APPEAL SUMMARY

Appeal ID: 15941	Project Address: 1127 SW Morrison St
Hearing Date: 10/11/17	Appellant Name: Montgomery Hill
Case No.: M-003	Appellant Phone: 971-242-8128
Appeal Type: Mechanical	Plans Examiner/Inspector: Eric Gessner, Thomas Ng, Joe Thornton
Project Type: commercial	Stories: 6 Occupancy: A-2 or M, B,S-1,S-2 Construction Type: Type II-A
Building/Business Name: SW Morrison Mixed Use	Fire Sprinklers: Yes - ENTIRE BUILDING
Appeal Involves: Correction of a violation	LUR or Permit Application No.: 17-113447-FS
Plan Submitted Option: pdf [File 1]	Proposed use: Office & Retail

Appeal item 1

CORRECTION NOTICE

SW 12TH & MORRISON
EXCERPT FROM SHEET M201

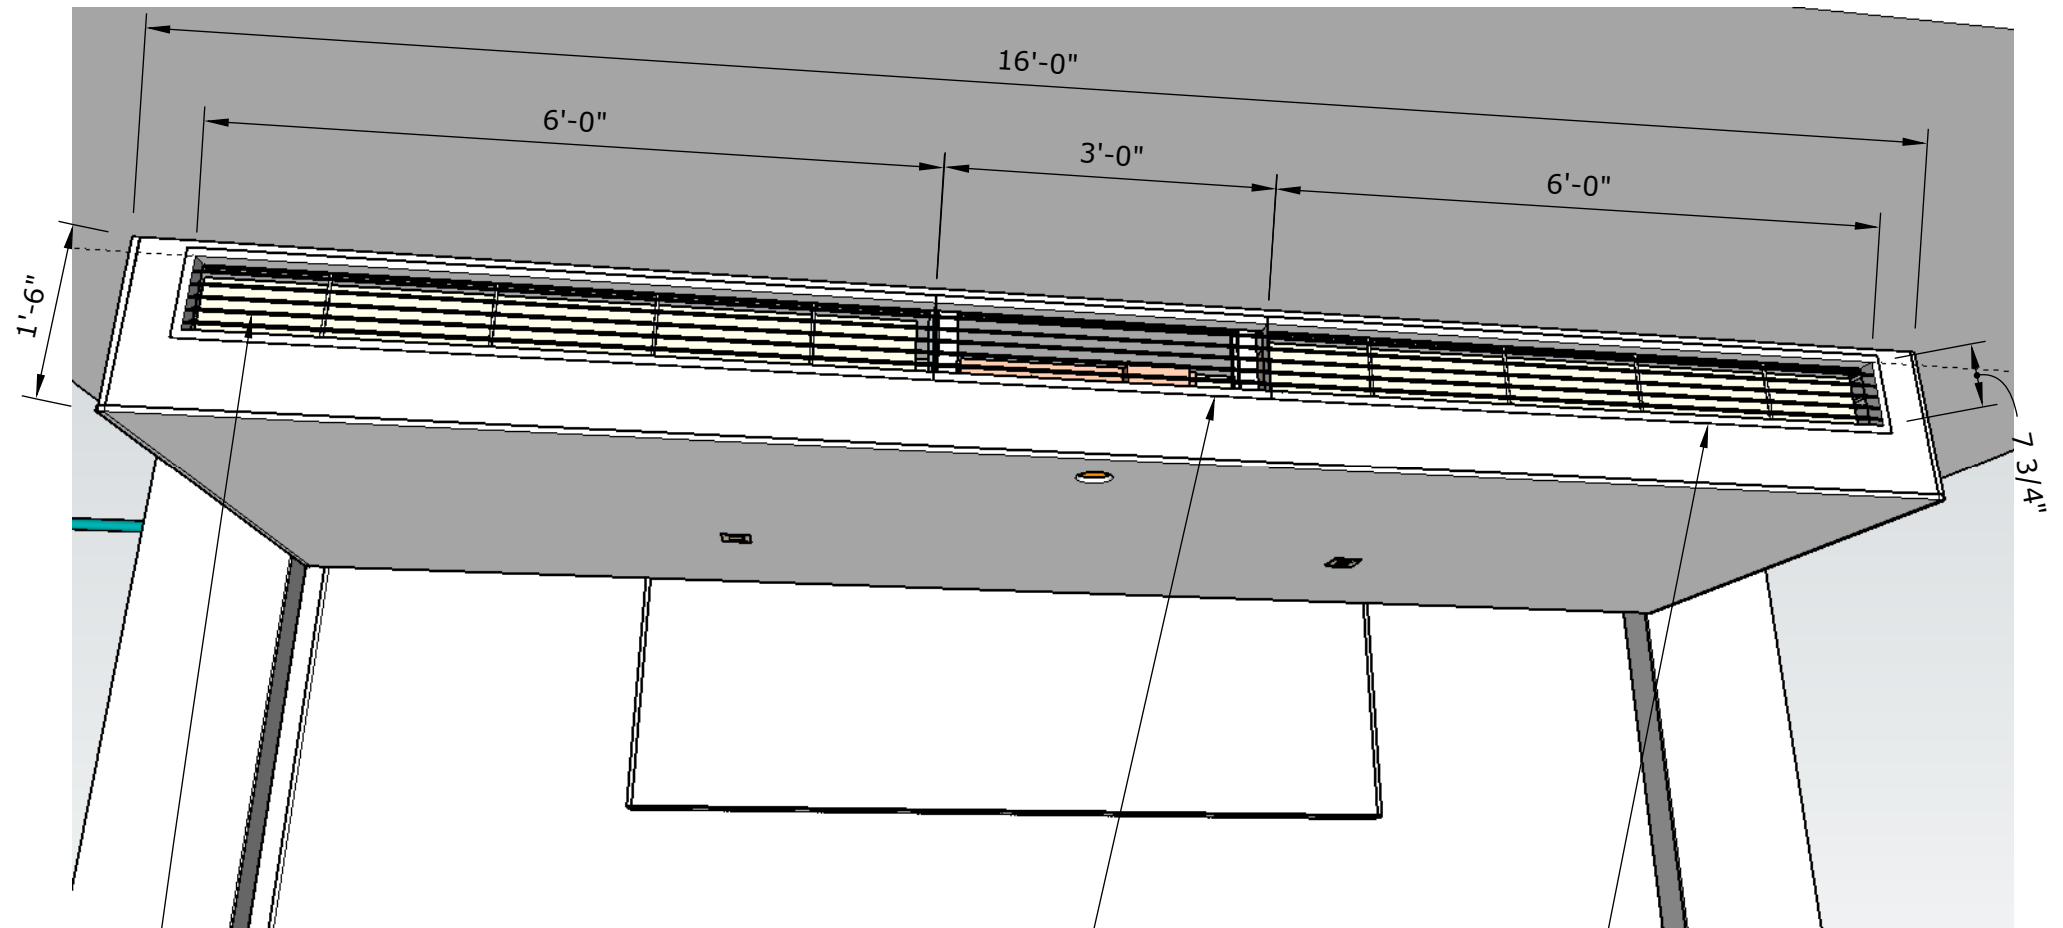
Our customer is so adamant about this issue they would like for us to appeal your inspector's request. Interface Engineering fully agrees with the side-of-unit access panel approach, based on the fact that a simple sheet rock soffit should not be considered a "permanent construction" as clarified in the code. It is a "planned temporary construction" to provide a finished look in the Lobby, with proper access to service all components which need servicing (filter and electrical/refrigerant access gained through the access panel at the side of the unit). This is typical of virtually all installations previously approved by the City of Portland, including the nearly identical condition described in the approved City of Portland Appeal #15153. A floor plan is included in this submission, with Note #7 on sheet M2.01 indicating the design intent for the access panel at the side of the unit. Additional soffit sketches are also included, demonstrating the extensive coordination of fan coil and soffit framing to allow for the simple removal of the fan coil. We believe it would be in the best interest of the Owner and final product to provide only the access panel at the side of the fan coil. The gyp board beneath the fan coil can be cut out when the equipment needs to be replaced, rather than installing a large minimum 50x36 access panel.

Mechanical equipment
Above elevator lobby shall
be Accessible without Removing
permanent construction

Access to fan coil by removal of drywall panel: Hold for additional information.

SW 12TH & MORRISON
SOFFIT AS DESIGNED

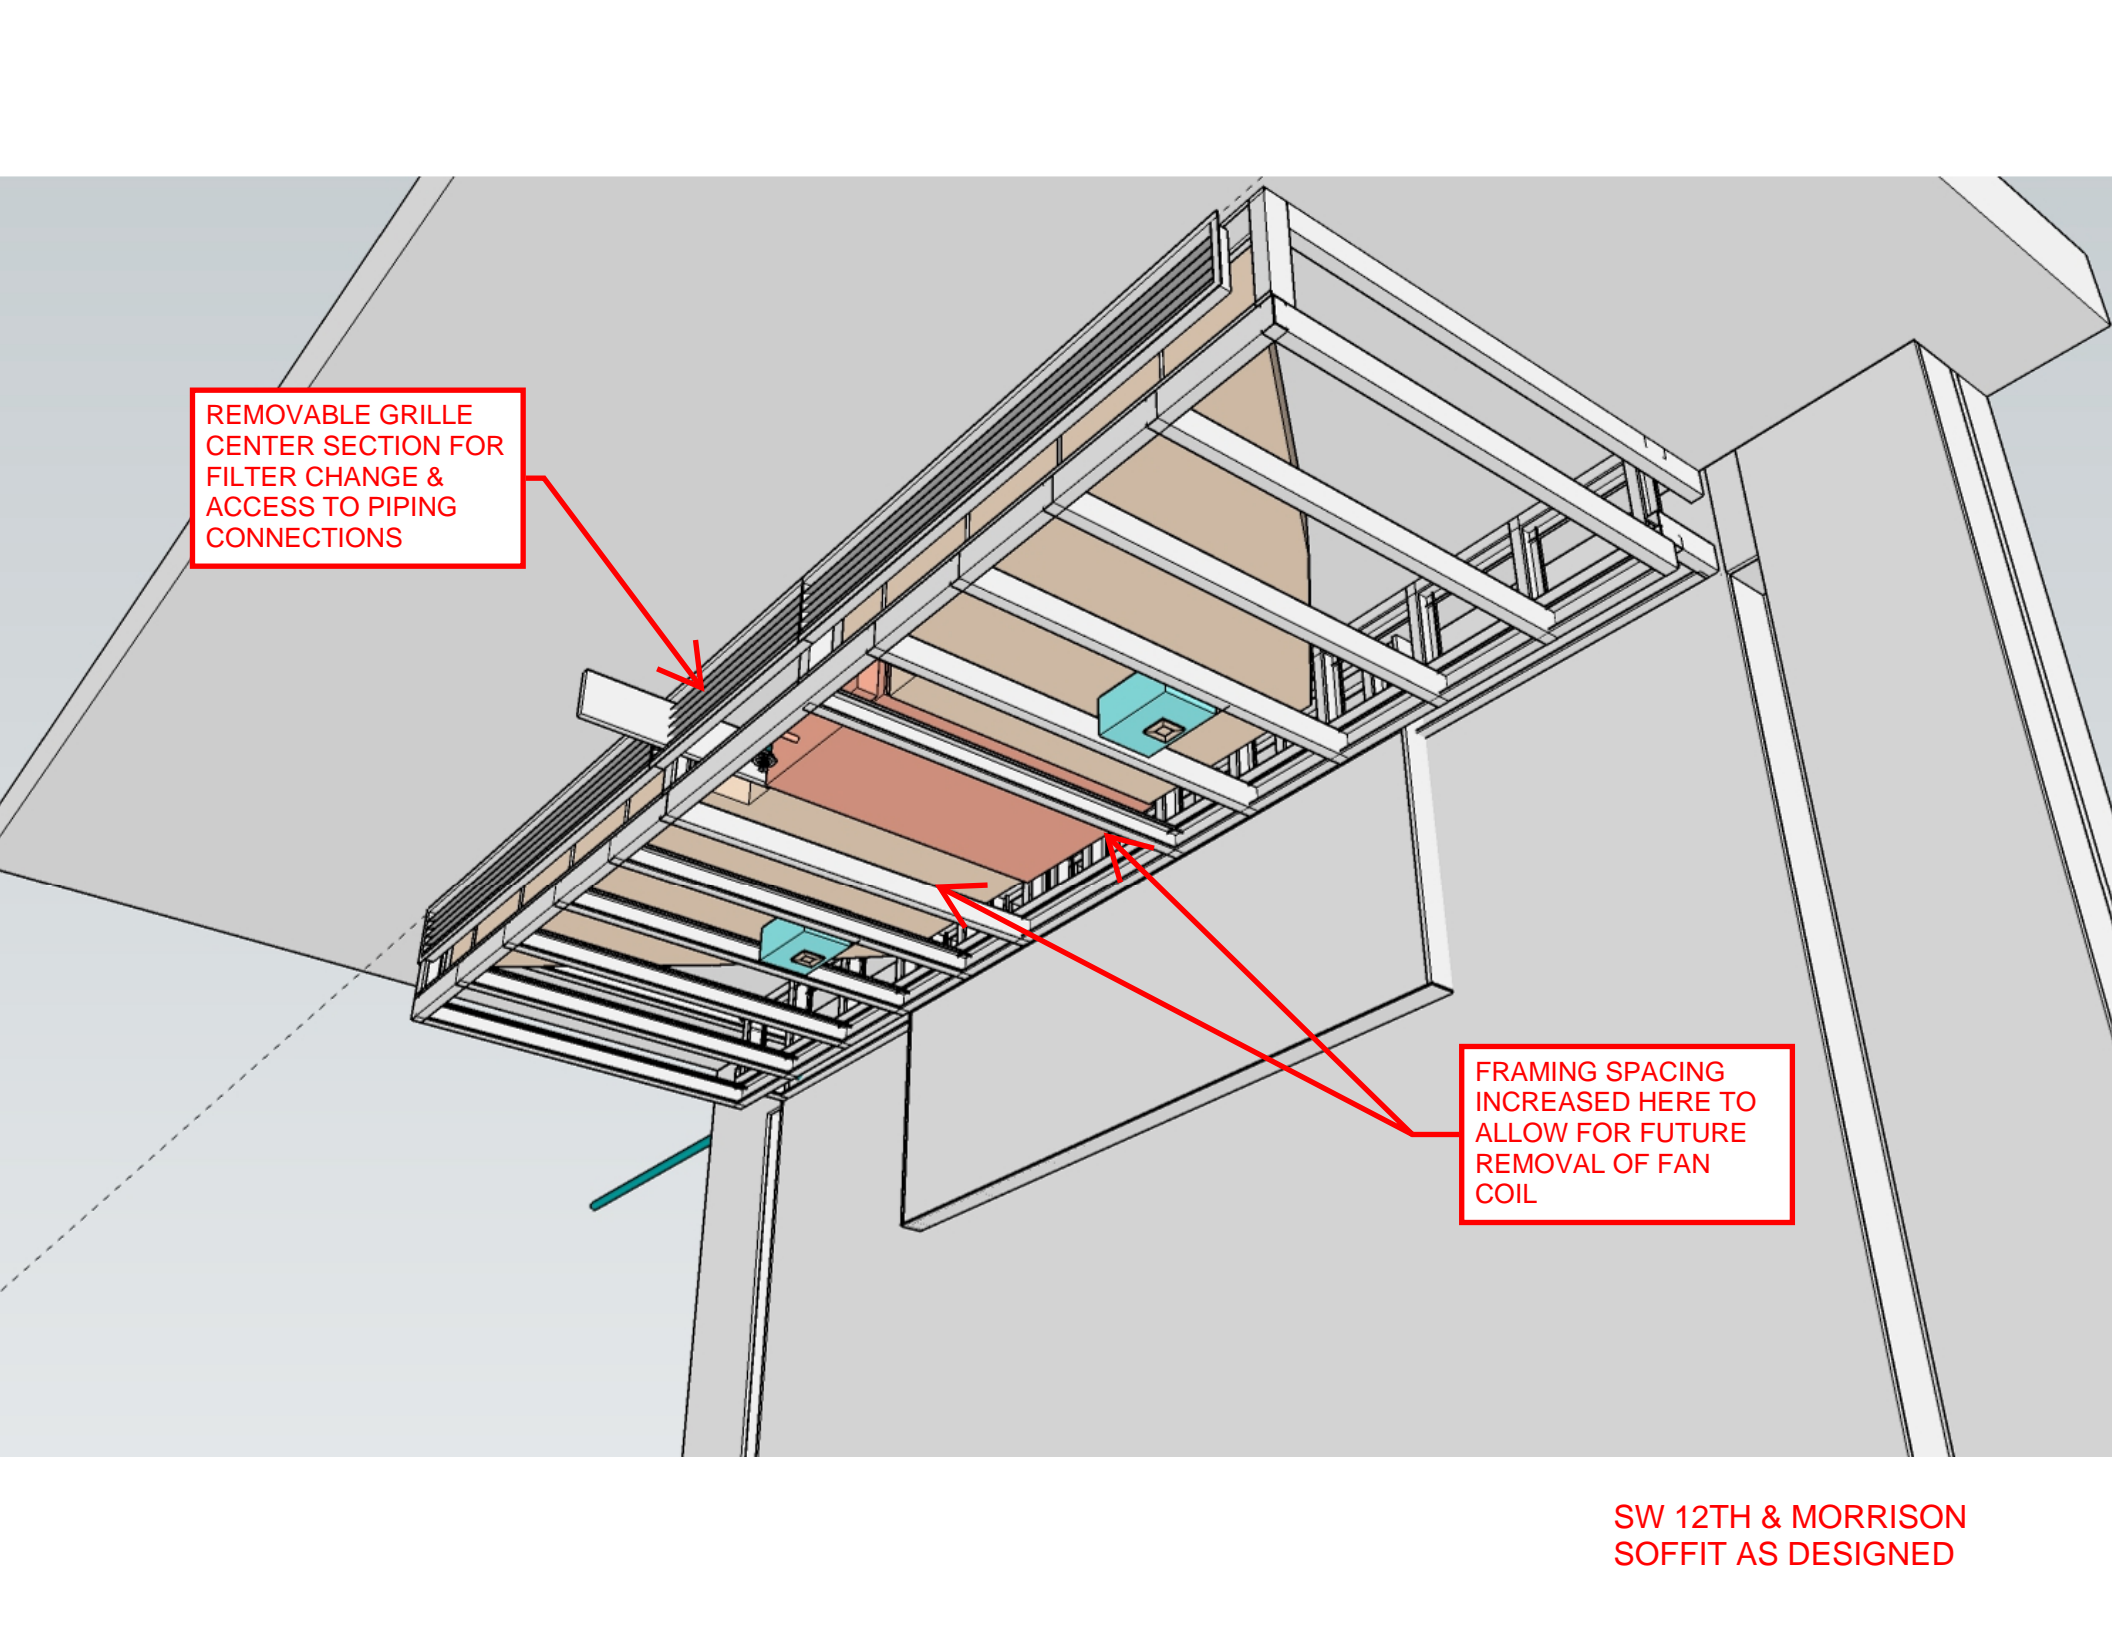
REMOVABLE GRILLE
CENTER SECTION FOR
FILTER CHANGE &
ACCESS TO PIPING
CONNECTIONS

FRAMING SPACING
INCREASED HERE TO
ALLOW FOR FUTURE
REMOVAL OF FAN
COIL

SW 12TH & MORRISON
SOFFIT AS DESIGNED

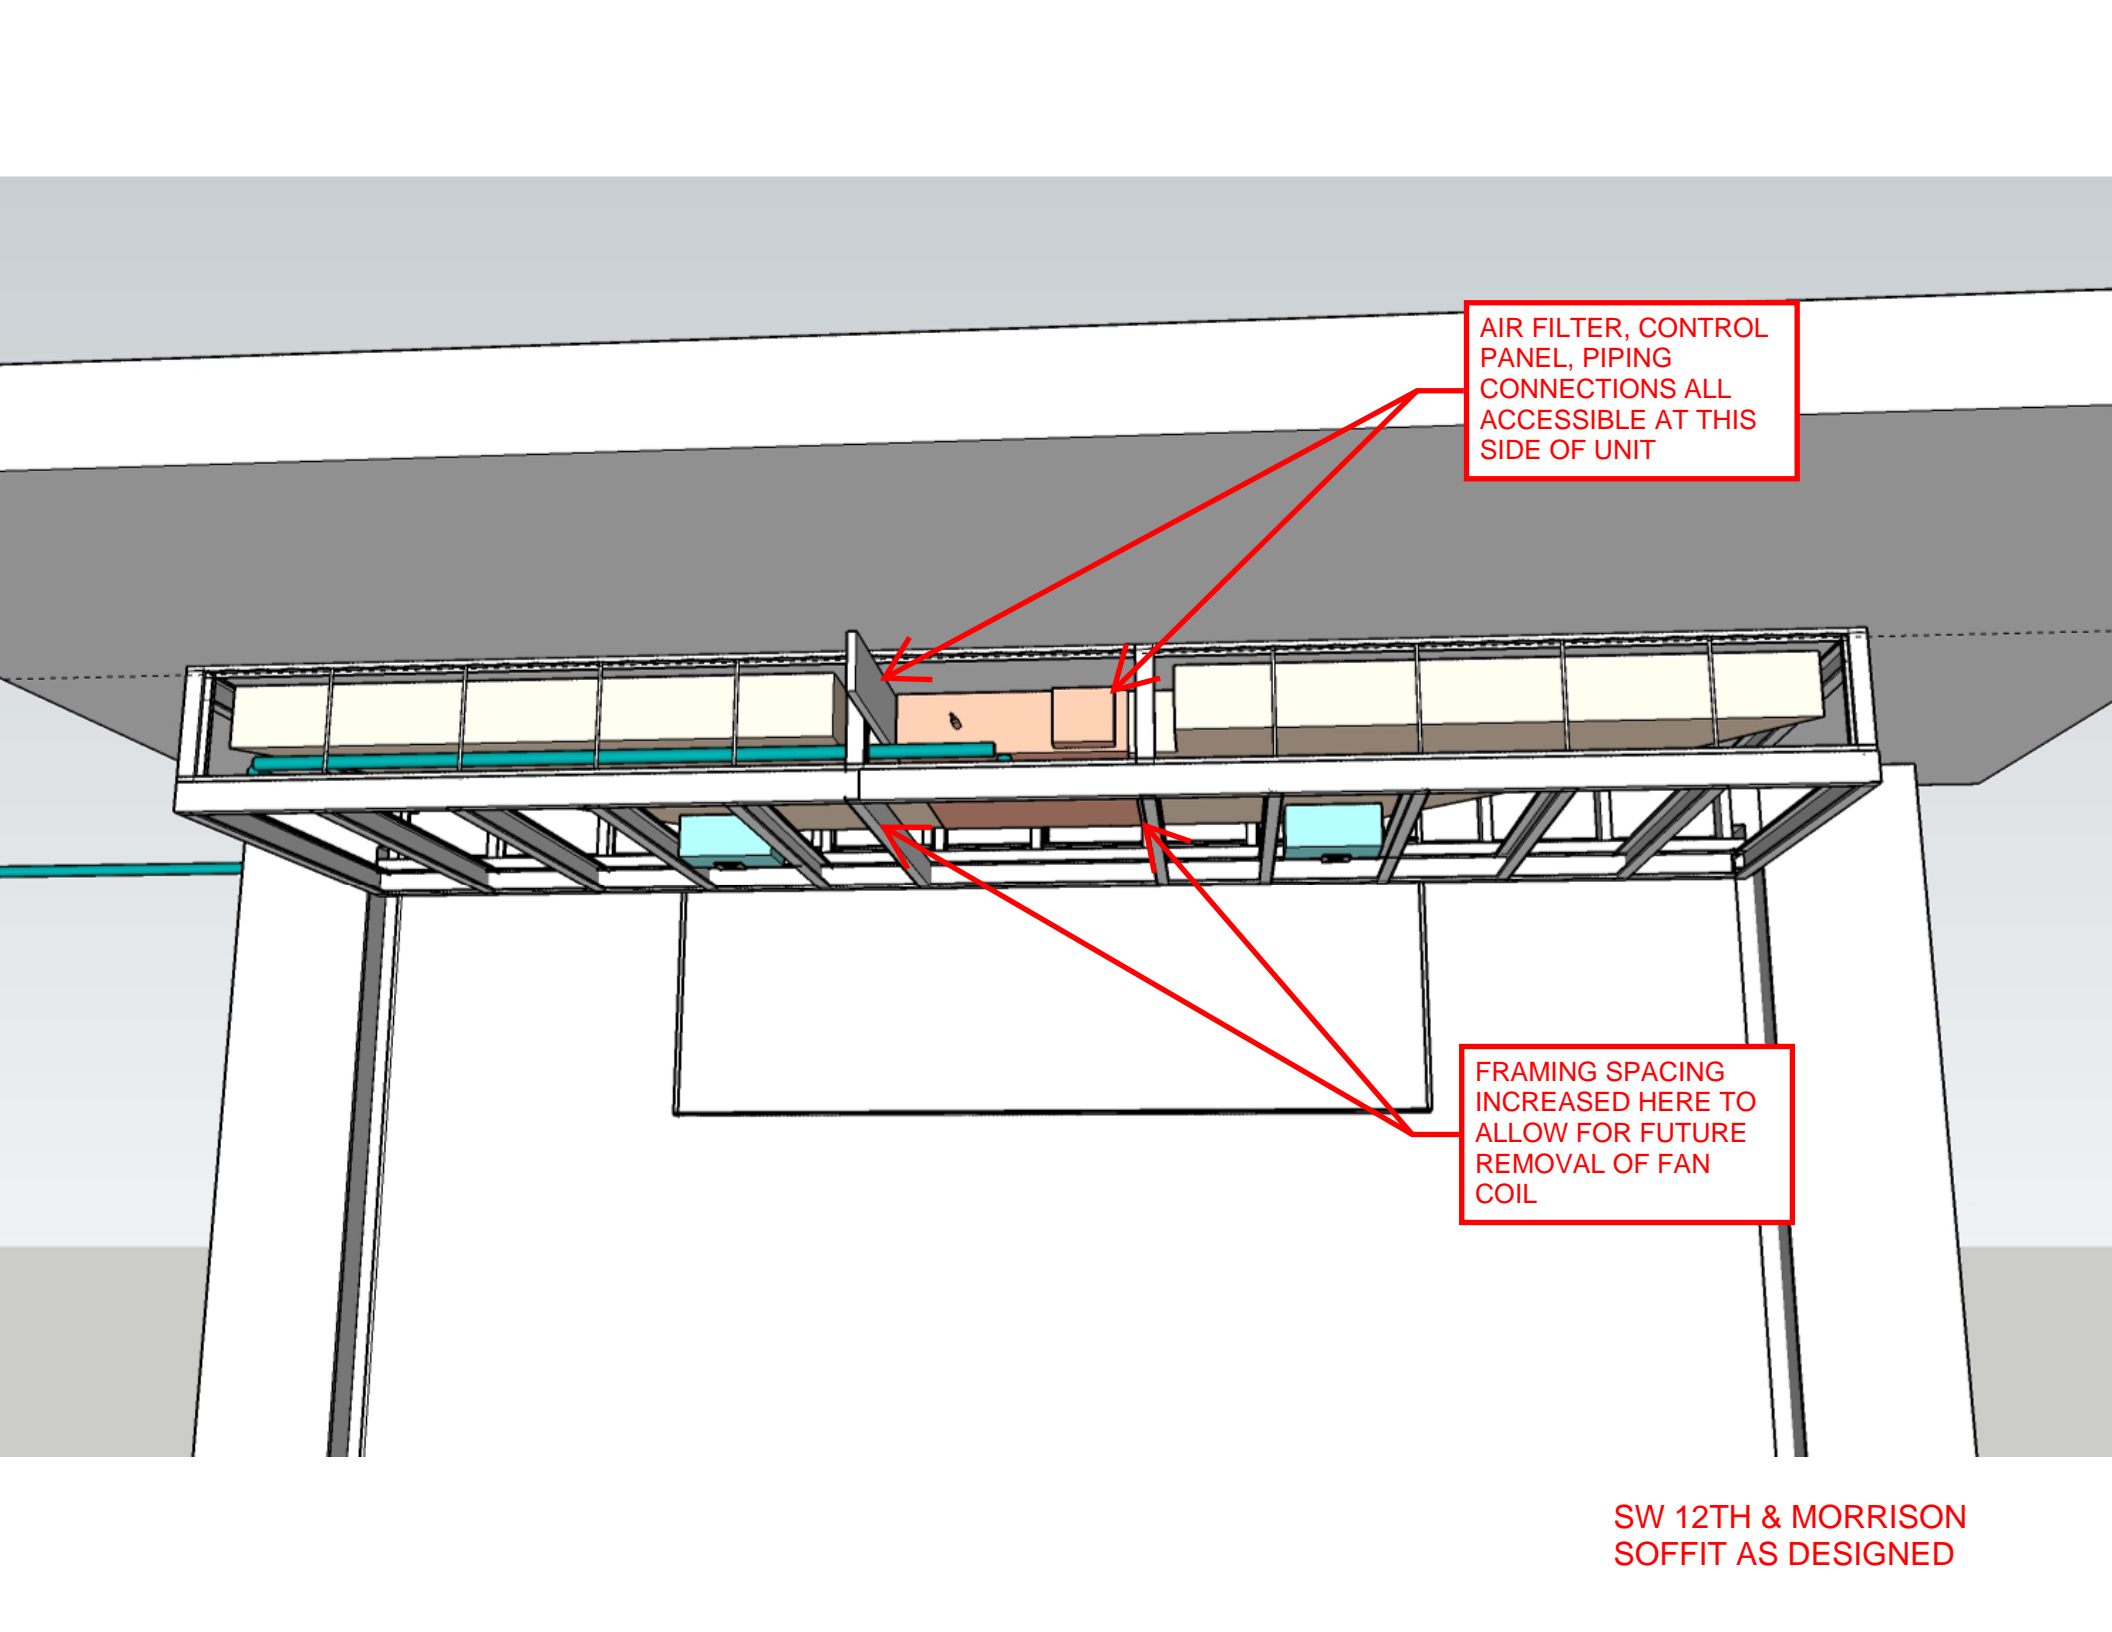
AIR FILTER, CONTROL
PANEL, PIPING
CONNECTIONS ALL
ACCESSIBLE AT THIS
SIDE OF UNIT

FRAMING SPACING
INCREASED HERE TO
ALLOW FOR FUTURE
REMOVAL OF FAN
COIL
